Portable Power Service News | Oil System

Scavenge System arrangement change 9/274-9/304-12/254-17/244-21/224

[Figure 1]

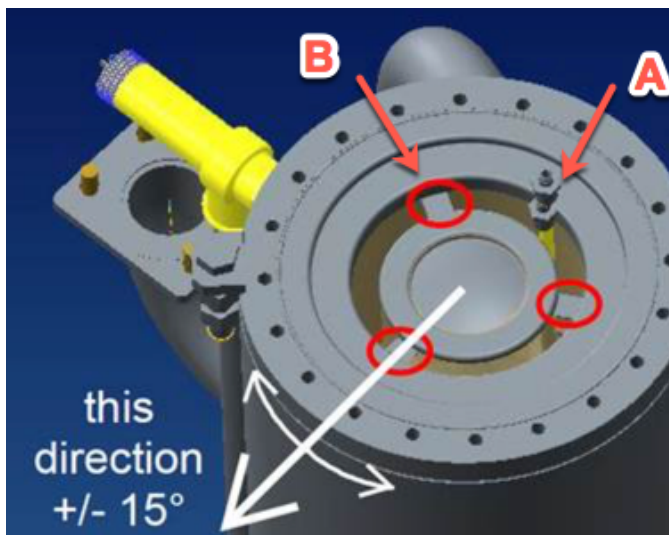
From factory these scavenge systems had been assembled using a section of steel pipe connected to a plastic hose. (Figure 2)

It was however observed that there is a potential for increased oil carryover due to a defect of the plastic hose just below the connection with the steel pipe.

Should your machine be subject to increased oil carryover , check the hose for damage and correct using the steel replacement pipe if required.(Figure 3)

When installing the new pipe, please observe the location of the filter reinforcement brackets in relation to the scavenge pipe to ensure they do not make contact. (Figure 1)

The full length steel pipe can be ordered under cpn 46553340.

The new full length steel pipe was installed in production from serialnumber:

- 17/244-21/224 → 883127
- 9/274-9/304-12/254→ 895257
